## 3200 Reid's Lane Subdivision Conceptual Servicing and Stormwater Management Report

**Re: Conceptual Servicing and Stormwater Management Report  
Reid's Lane Subdivision  
3200 Reid's Lane, Ottawa, ON  
Response to Comments  
Our File No.: 119089**

**Re: Draft Plan of Subdivision Application – 3200 Reid’s Lane (1<sup>st</sup> review)**

Subject: Crestview Innovation Inc.  
Plan of Subdivision Application D07-16-21-0028  
3200 Reid's Lane, formerly Osgoode, now City of Ottawa

*Draft Plan of Subdivision*, Project No. 119089, prepared by Novatech Engineering, dated 2021/06/07.

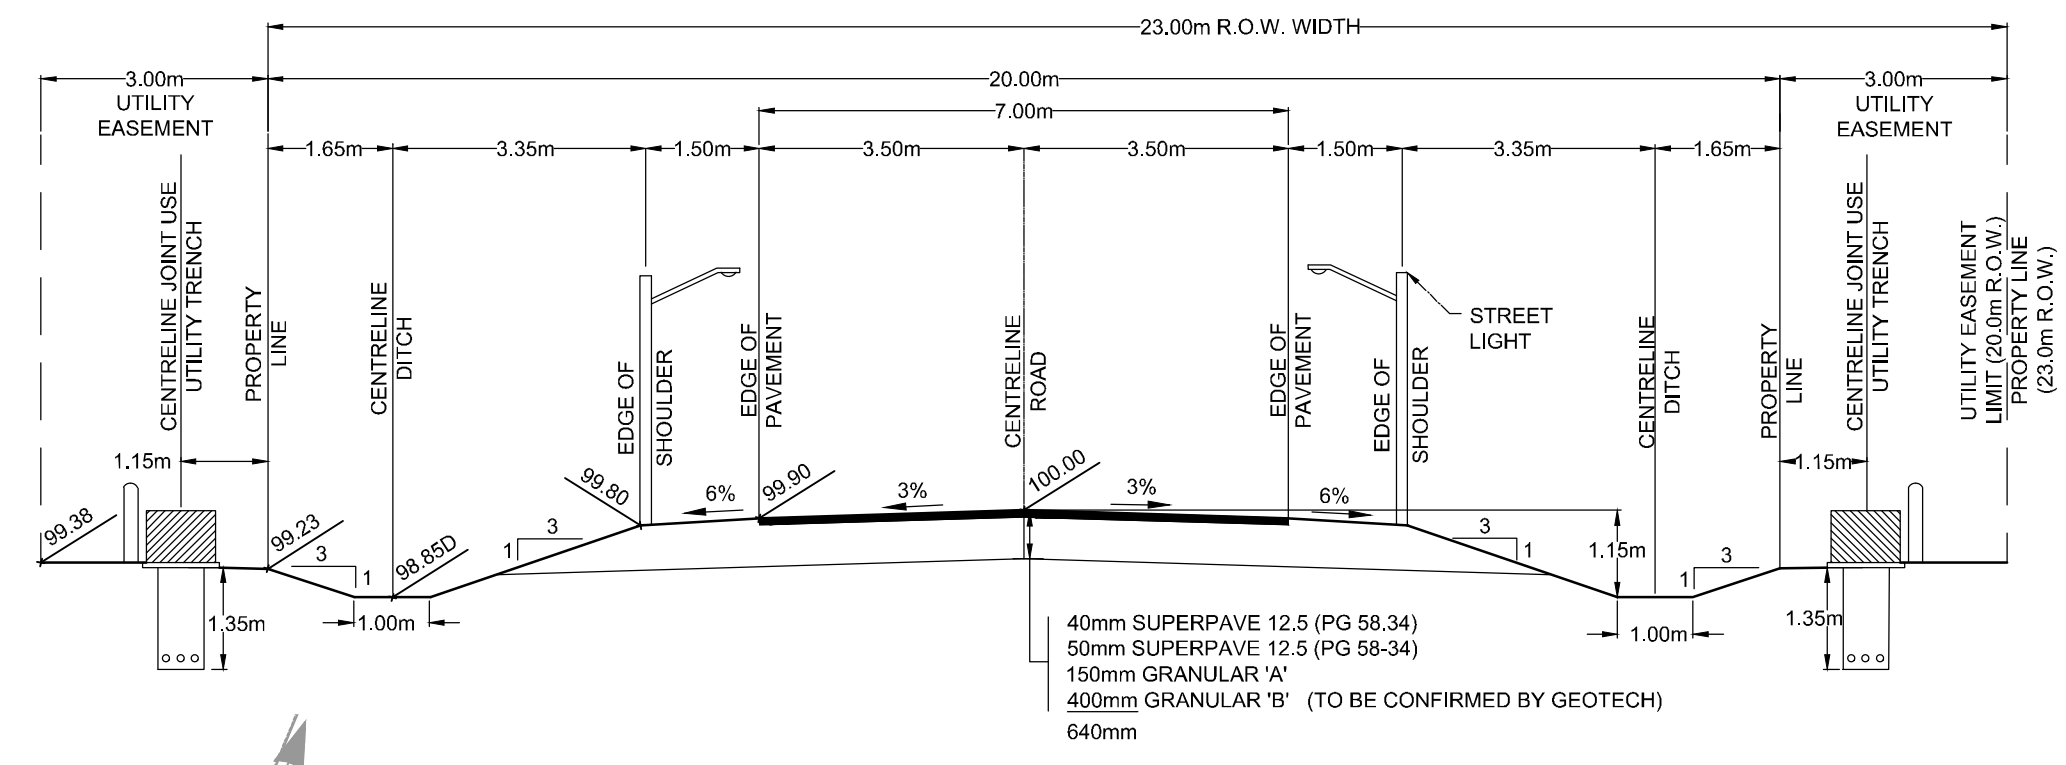
5. At this time, there is reluctance to convey 3-metres (approximately) of Peace Park for a 23-m Right-of-Way when it appears the 20.5 metres shown on the Draft Plan would be sufficient and, given that a 23-metre ROW would require disposal of City-owned Parkland, which is generally avoided to the greatest extent possible. If 20.5 metres is not going to be sufficient, please provide rationale as to why the additional 3-metres is required.

*Preliminary Grading Plan*, 119089-PGR, prepared by Novatech Engineering, dated Sept 03/21.

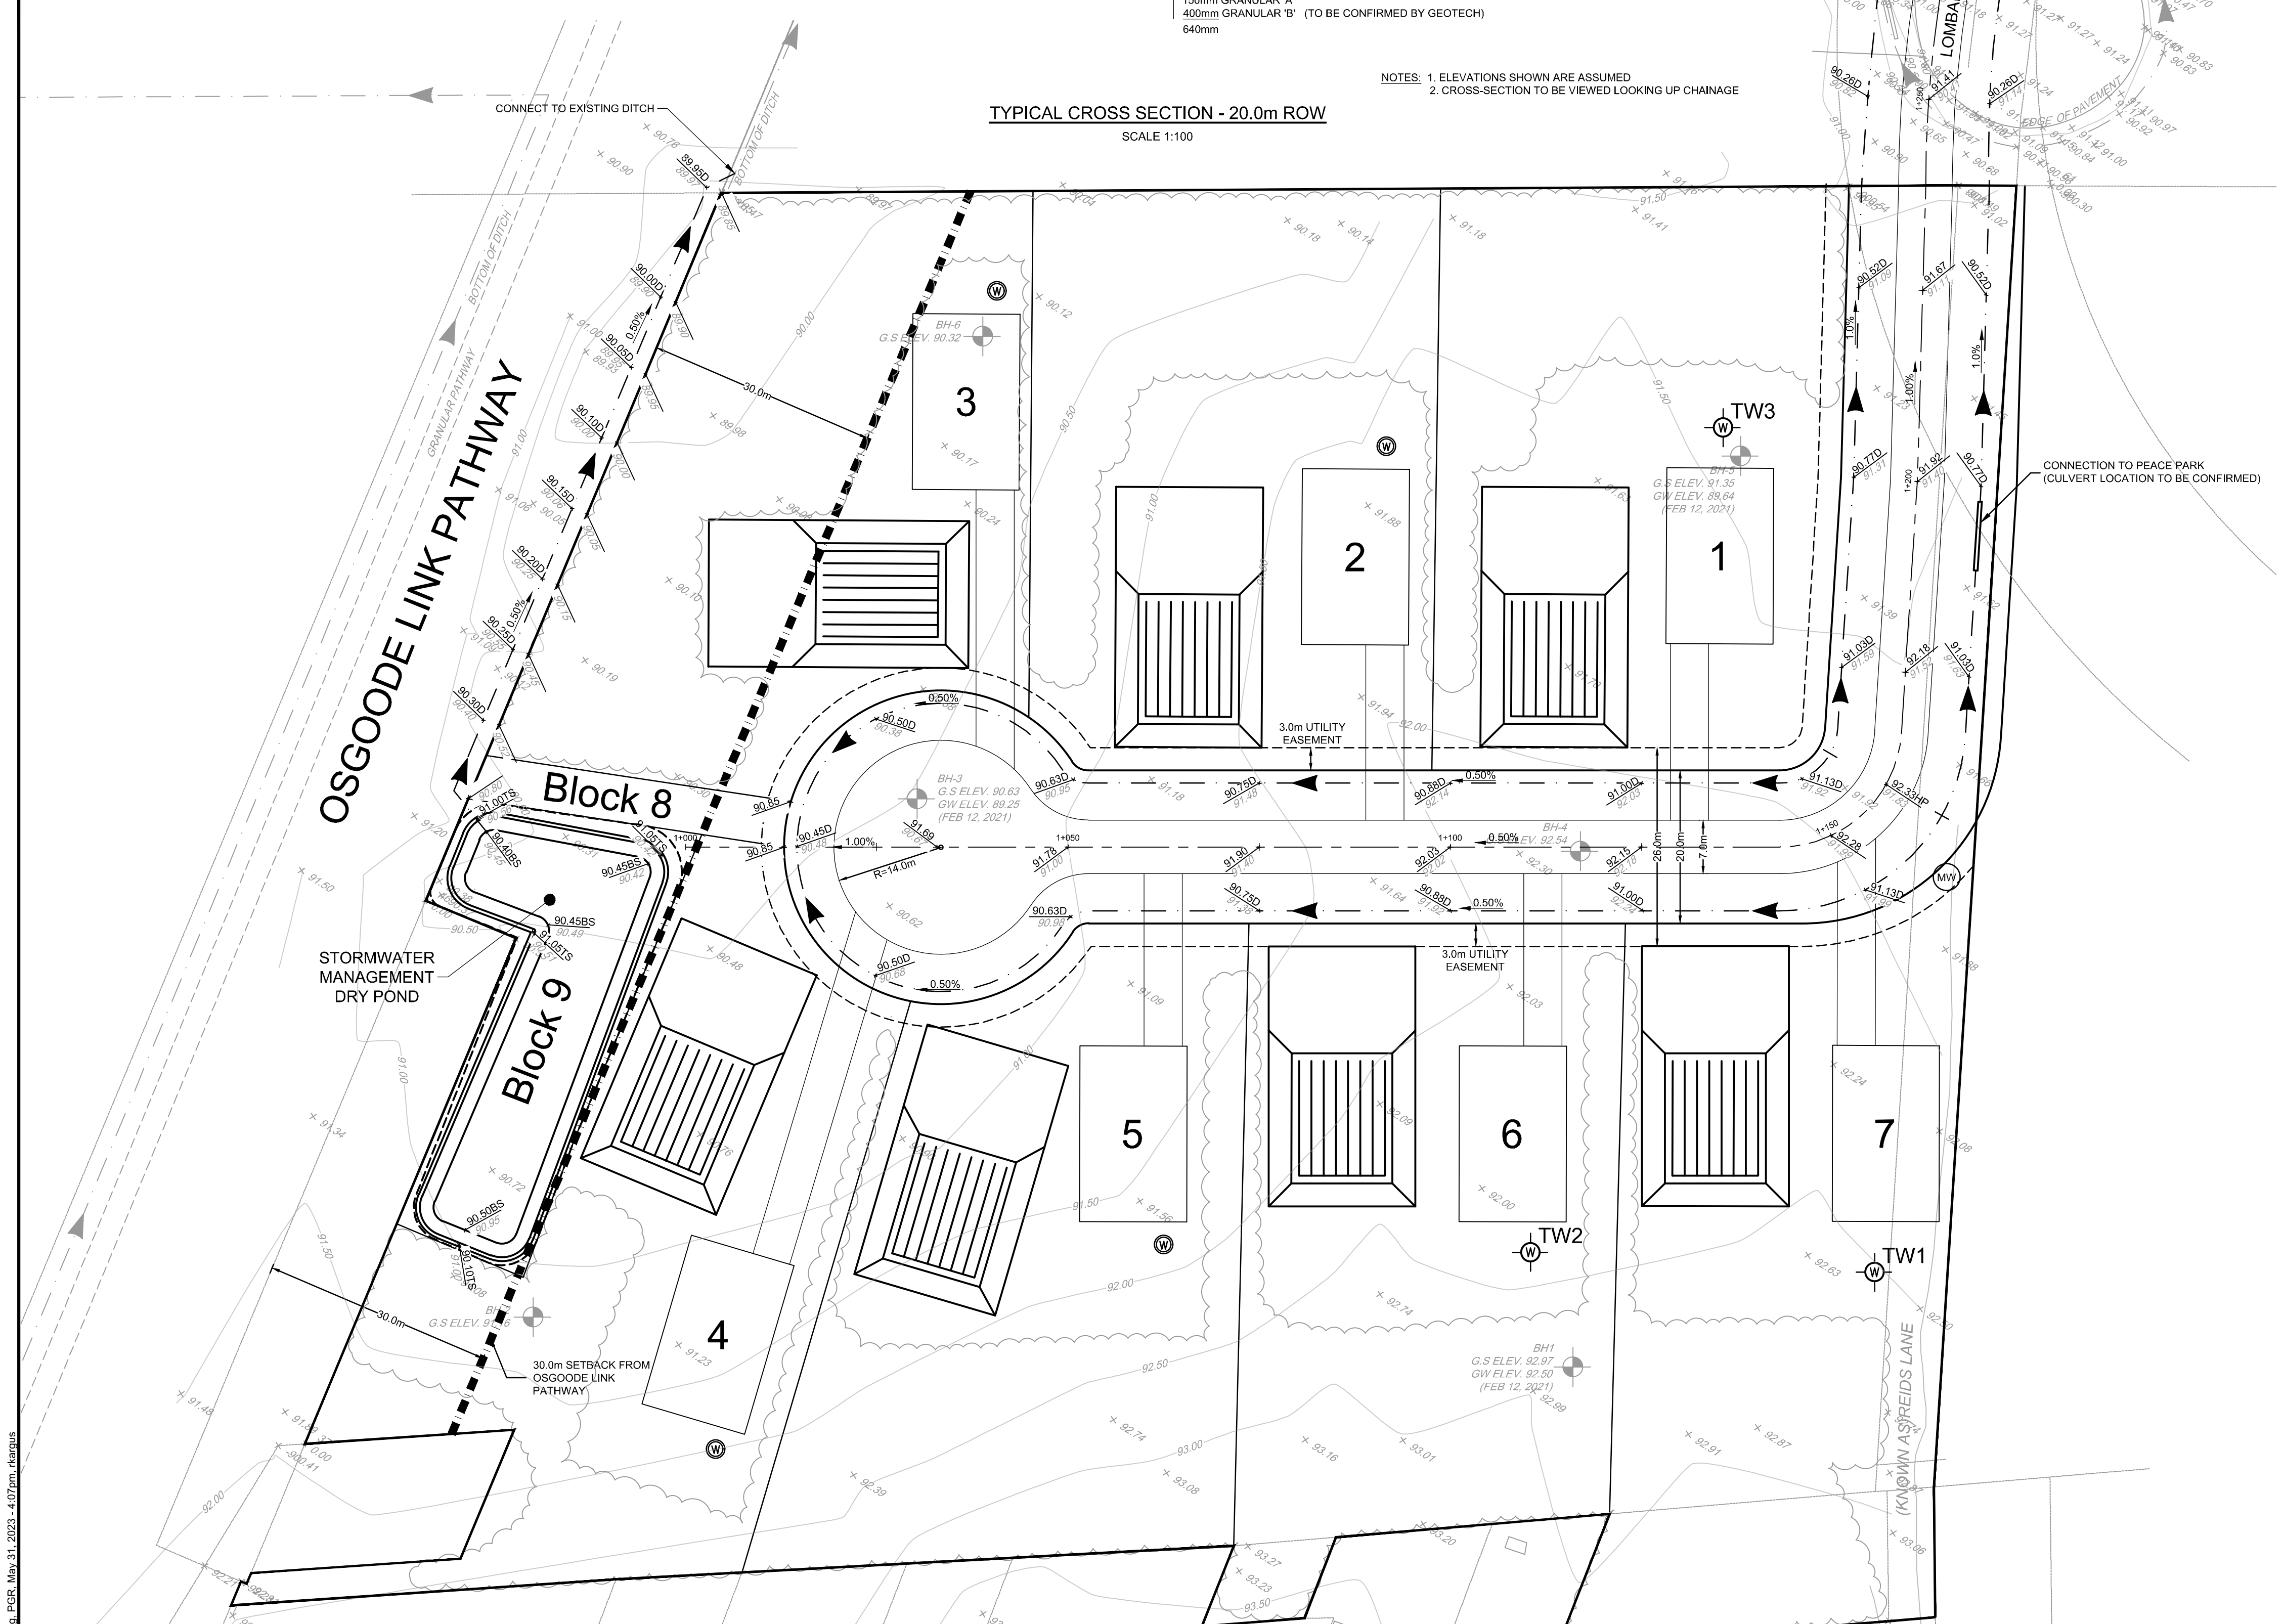
21. Please ensure this plan coordinates with the EIS and Tree Conservation Report to maximize tree retention.
